# City Planning Department

## Memo

To: Cranston City Plan Commission  
From: Alexander Berardo – Planning Technician  
Date: September 30, 2022  
Re: **Dimensional Variance @ 1340 Plainfield Street**

**Owner/App:** Anyyong Suk Woo  
**Location:** 1340 Plainfield Street, AP 12, Lots 406 & 409  
**Zone:** C-2 (Neighborhood Business)  
**FLU:** Highway Commercial Services

# SITE PLAN

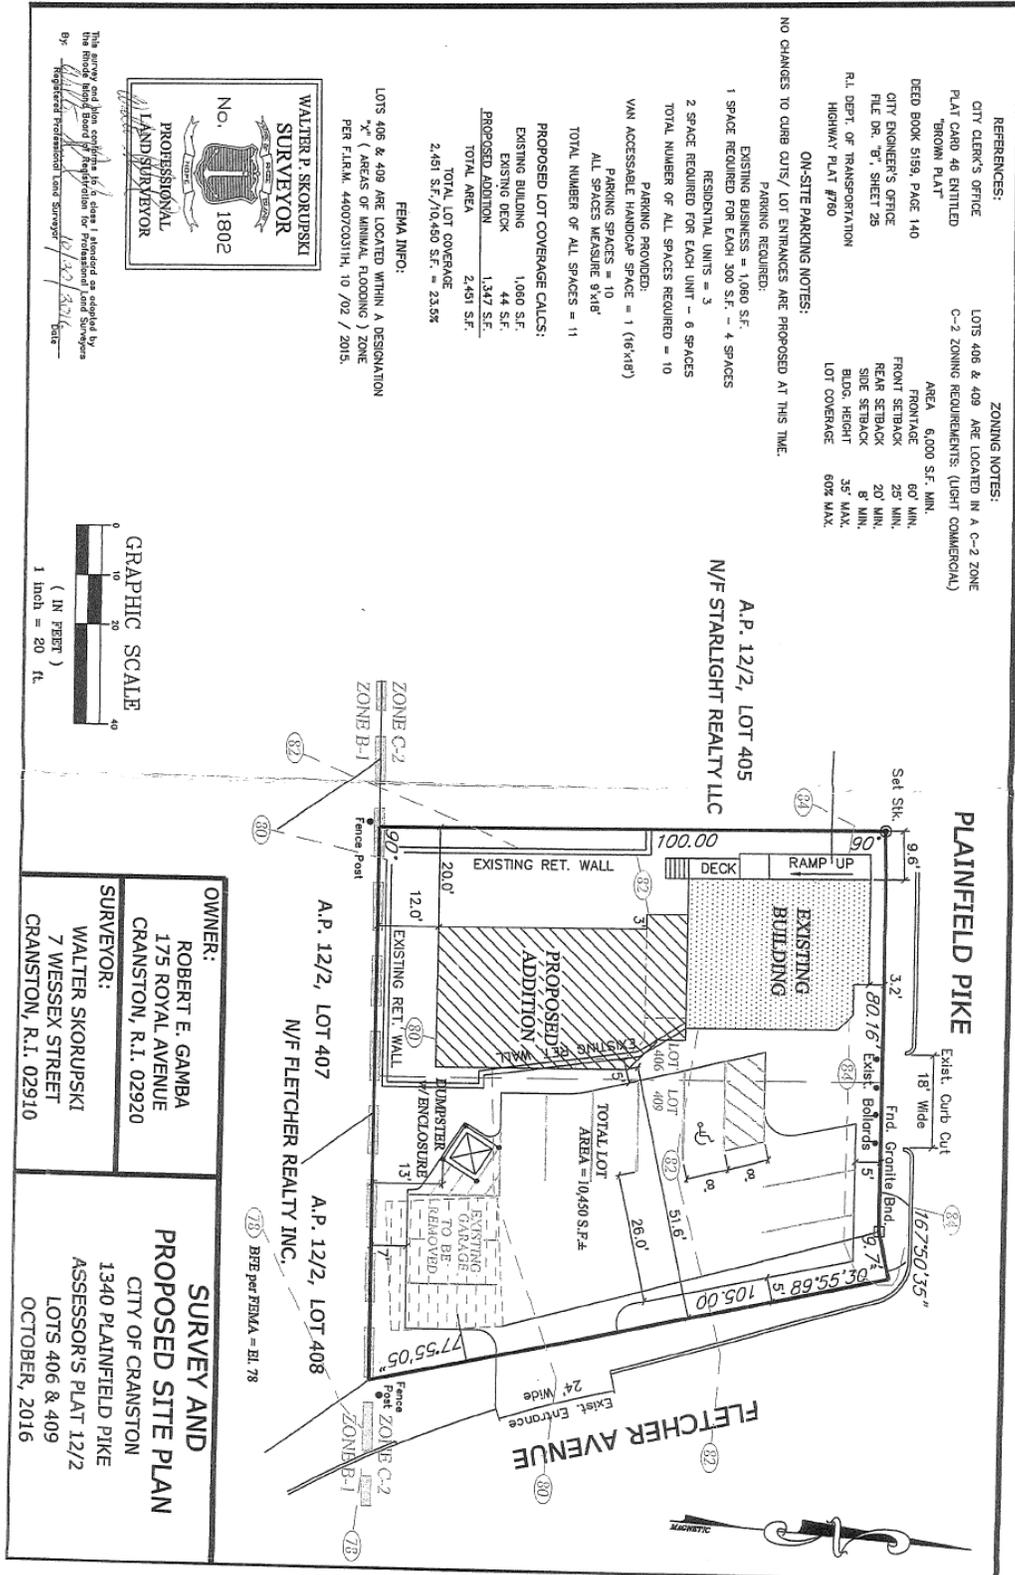
3. The parcel is a corner lot, so its buildable envelope is inherently constrained by the additional front setback. The proposed addition would come within 12 feet of the lot line it shares with AP 12, Lots 407 and 408. If this lot line is interpreted as a side lot line instead of a rear lot line, the addition would conform to the 8-foot setback requirement.

4. The applicant also proposes to demolish the existing garage in the rear of the property (nearer to Fletcher Ave) and replace it with three surface parking spaces. The site plan shows a total of 11 off-street parking spaces being provided on the Fletcher Ave side of the parcel, which would exceed the minimum 8 required spaces (two for each of the four residential units) and comply with Section 17.64.010(F)(1)'s requirement that "vehicles will leave and enter the street with a forward motion" for multifamily residential uses.

1. The accessible parking space shall be reviewed and approval by the Building Official to be installed closest to the entrance providing an ADA-compliant accessible route.
2. Any landscaping and planting areas disturbed as a result of parking reconfiguration shall be reviewed and approved by the Building Official.
